Addendum No. 1
February 15, 2024

Project: W. M. Lee Center for Fine Arts – Art Studios
University of South Dakota
Vermillion, South Dakota
OSE Project #R0624--04X/DEL
Architecture Incorporated Project #3041

3) **DRAWING SHEET 4.00 – DEMOLITION FLOOR PLANS**

PARTIAL FLOOR PLAN - DEMOLITION

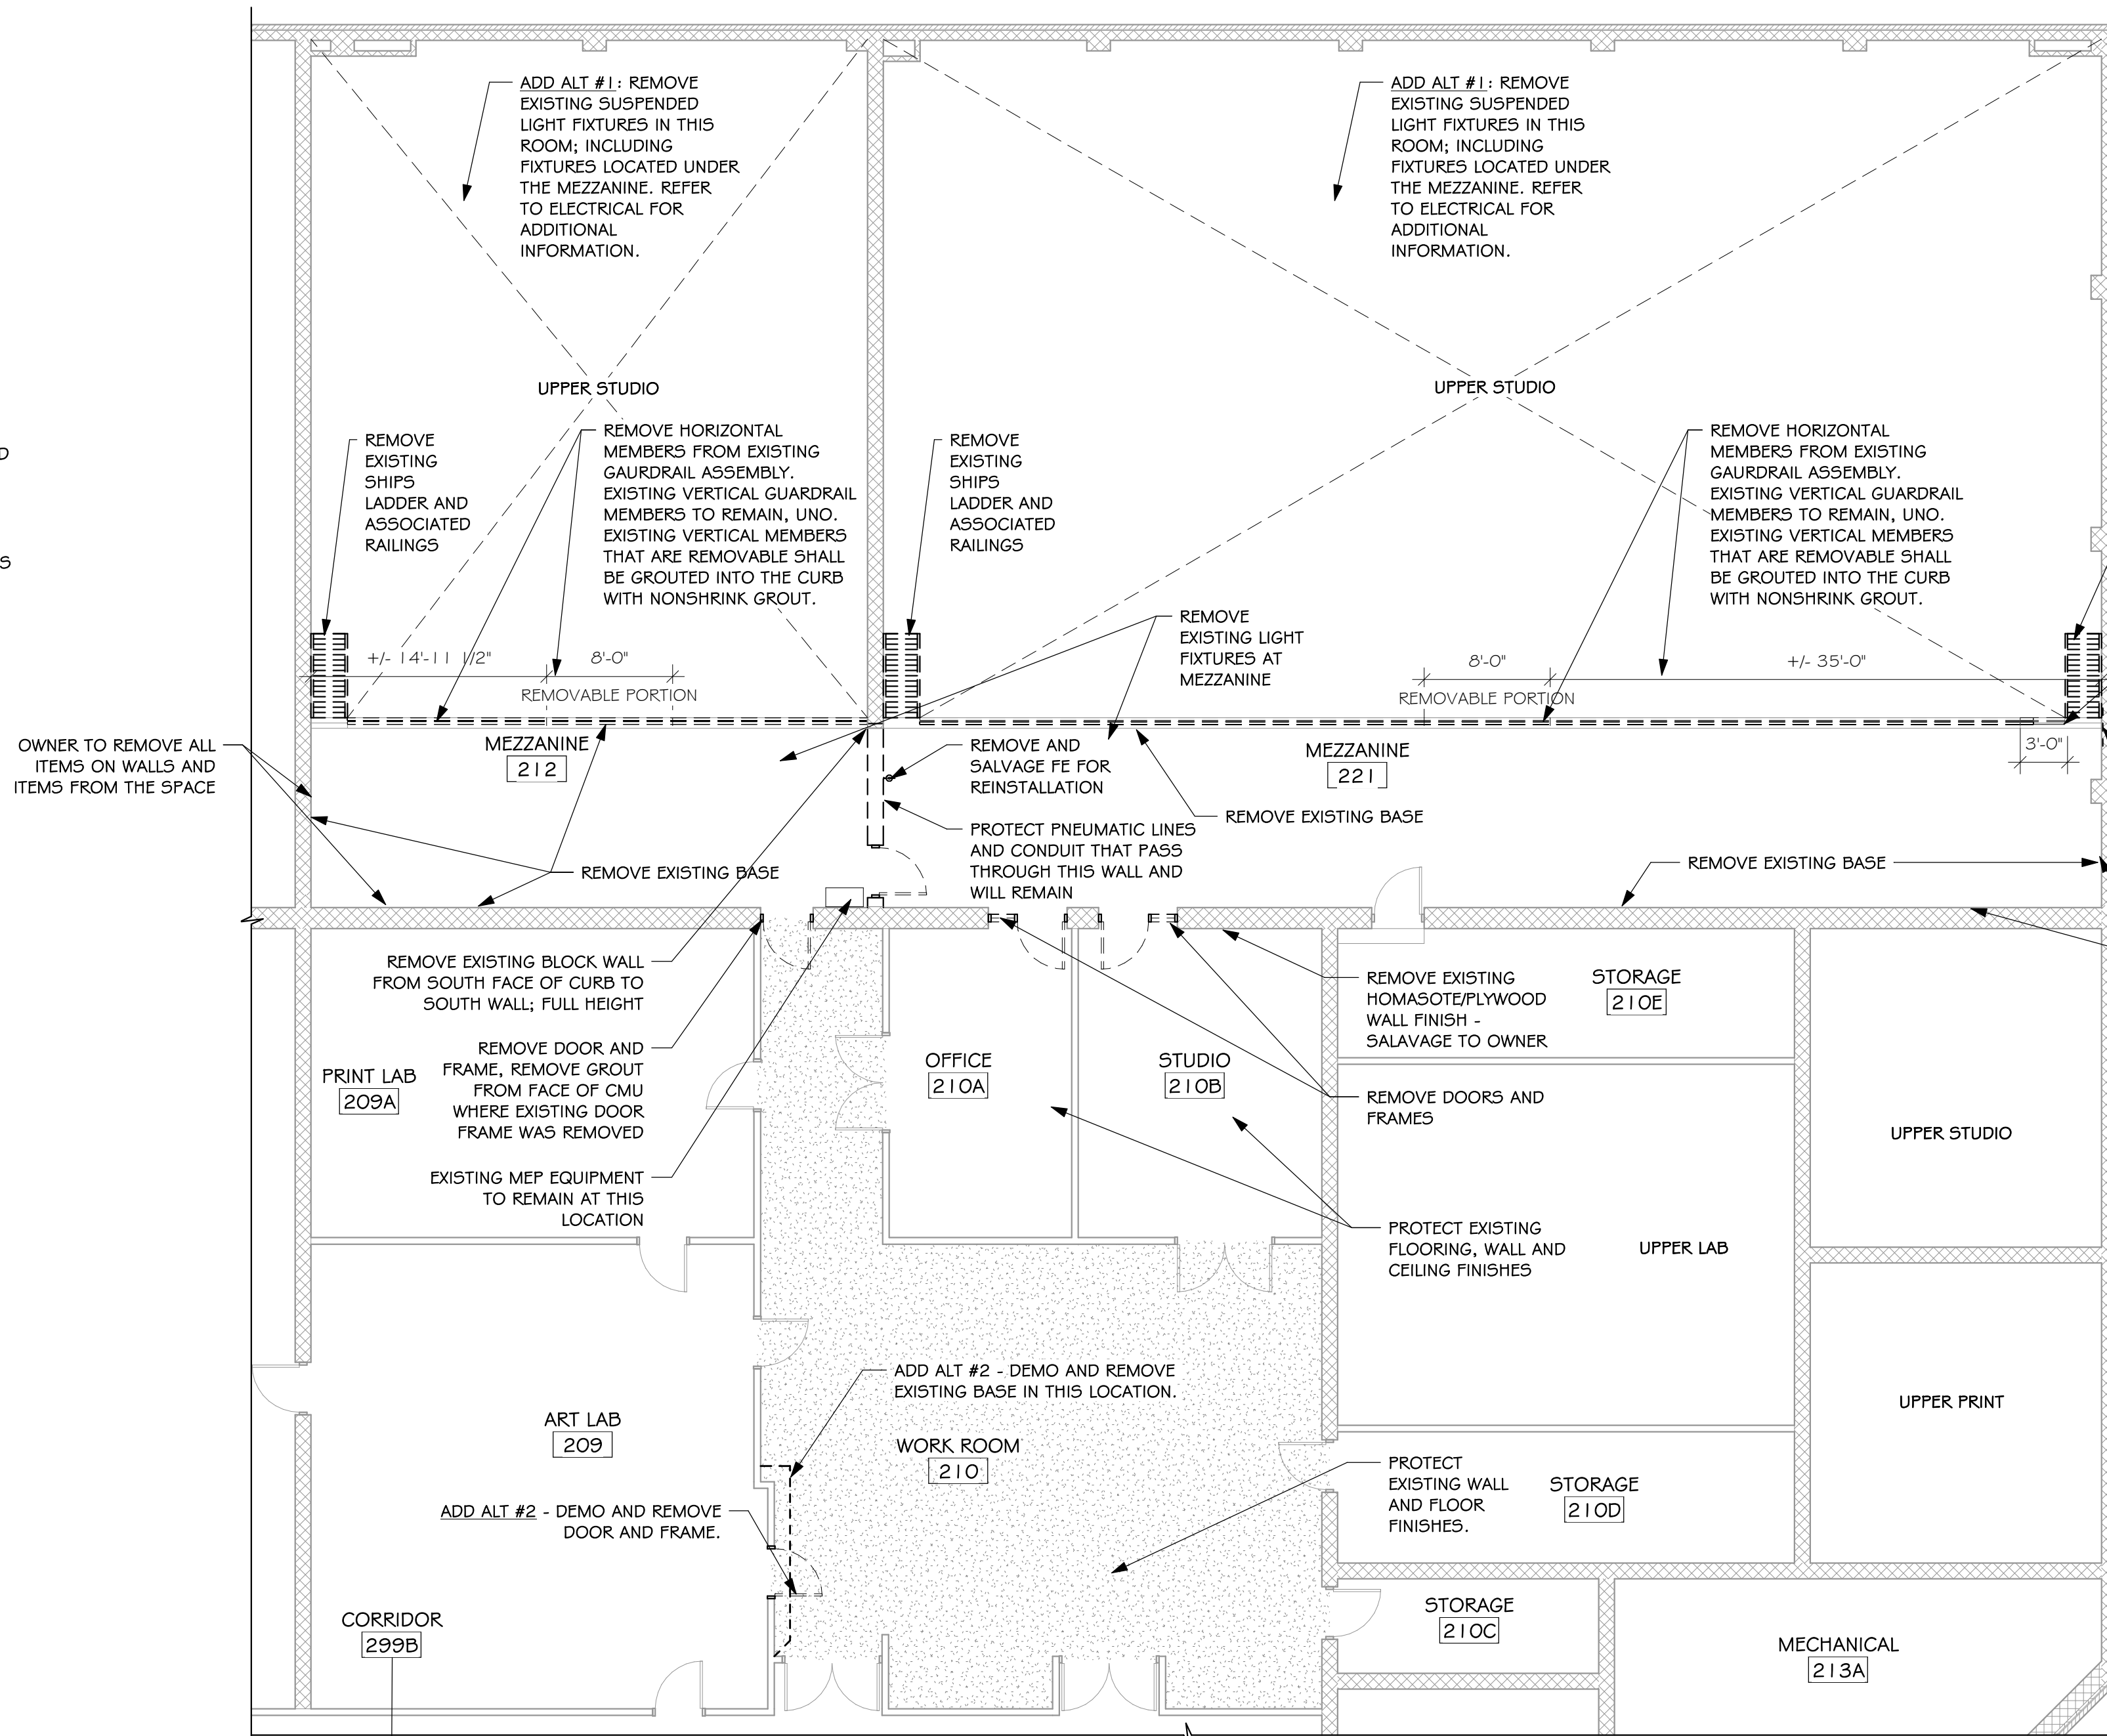
- a) PARTIAL FLOOR PLAN – DEMOLITION; The demolition floor plan view has been expanded to the west to more clearly show additional wood framed walls to be demolished in Studio (16)
- b) Reference revised drawing Sheet 4.00, revision dated 02-15-2024, attached to the end of this addendum for additional information.
